REPLAT AND SUBDIVISION PLAT ESTABLISHING COMMUNITY BIBLE CHURCH, UNIT-2

PRELIMINARY OVERALL AREA DEVELOPMENT PLAN
for
GOLD CANYON / LOOP 1604

Re: Community Bible Church, Unit-2
Plat No. 030072
Variance Request to Section 35-506(g)(1) for the Gold Canyon Road Extension

P.O.A.D.P #132-B Gold Canyon / Loop 1604

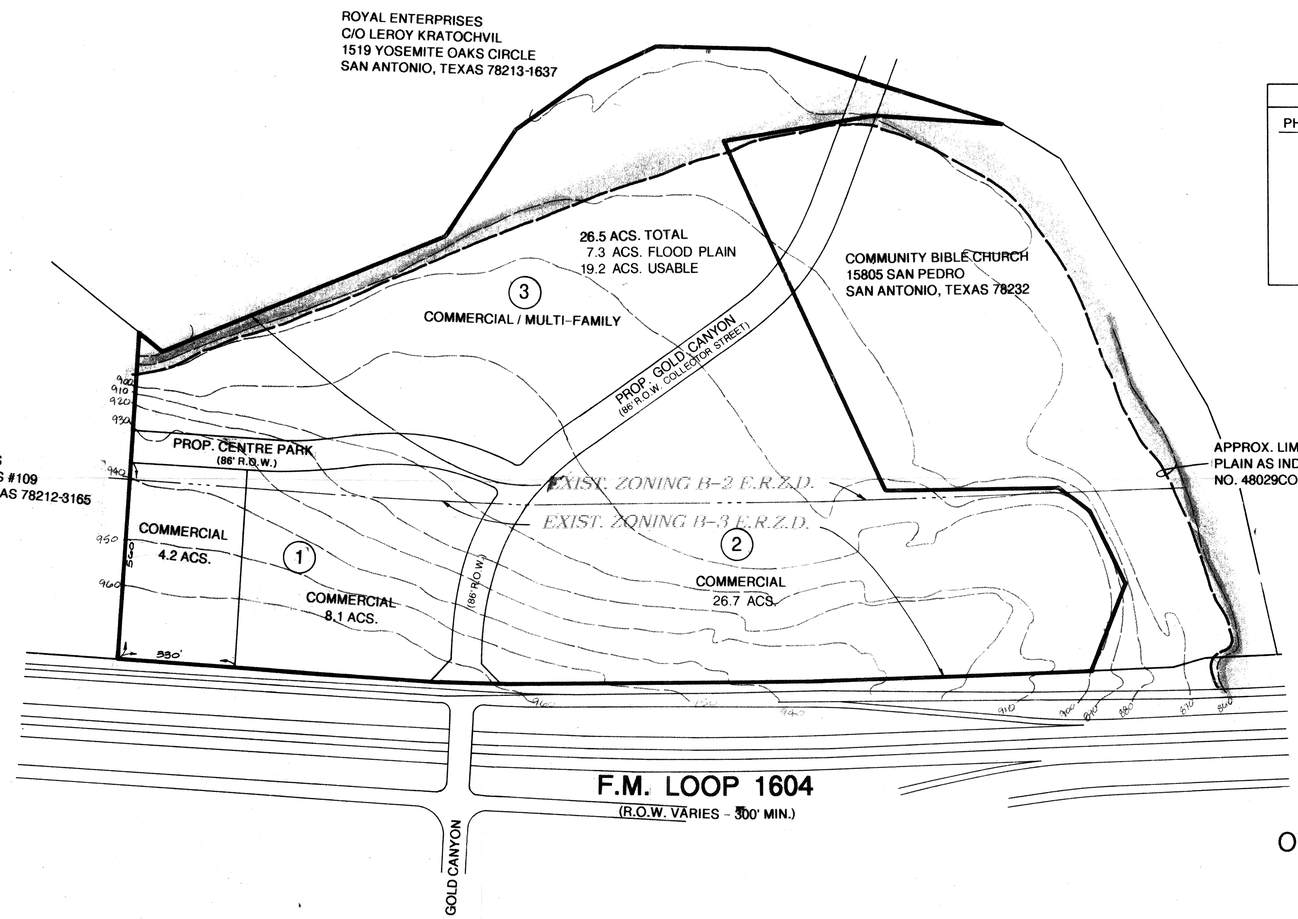
The City Staff Development Review Committee has reviewed Gold Canyon/Loop 1604 Subdivision Preliminary Overall Area Development Plan # 132-B. Please find enclosed a signed copy for your files. Although your plan was accepted, please note the following:

- Based on the topography, a Flood Plain Study and drainage review will probably be required during the platting process.
- This development will probably need to conform to requirements associated with development over the Edwards Aquifer. For information about these requirements you can contact SAWS at 704-7305.

- Access and ROW issues along State facilities will need to be resolved with the Texas Department of Transportation. For information about these requirements you can contact TXDOT at 615-5814.

- This development will need to comply with tree preservation ordinance #85262. For information about these requirements you can contact Building Inspections at 207-7102.

- It will be expected that you will plat all of the property depicted in your POADP, to include: floodpains, drainage areas and open space.
- I would encourage you to work closely with the school district, so that they can plan accordingly.

- The alignment of Gold Canyon Road and Centre Park Road will need to be resolved with the adjacent property owners.

1.) Provide Site Plan with ~~[illegible]~~ ~~[illegible]~~ access points to Gold Canyon.

2.) Will need Developer Agreement for GOLD CANYON CONSTRUCTION

3.) CANNOT SHIFT MAJOR THOROUGHFARE OVER TO ADJOINING PROPERTY.

1.) Developer will need to provide "Developer Agreement" towards construction of Gold Canyon as per U.D.C. Sec. 35-506 (g)(1)

Planning will not support a variance to the above mentioned U.D.C. Section.

- Coordinate location of proposed road alignments with adjacent property owners
- Comply with CSA Tree Ordinance.
- Submit Traffic Impact Analysis based upon potential uses under the existing zoning.
- Resubmit the POADP showing Gold Canyon as a continuous 86-foot wide right-of-way throughout limits of property.

REVISIONS:
1 REVISED 5-5-98 GOLD CANYON R.O.W. REDUCED TO 86' R.O.W. THROUGHOUT PROPERTY

- The POADP has been revised to indicate Gold Canyon Road with 86 feet of right-of-way width for its entire length within the property.
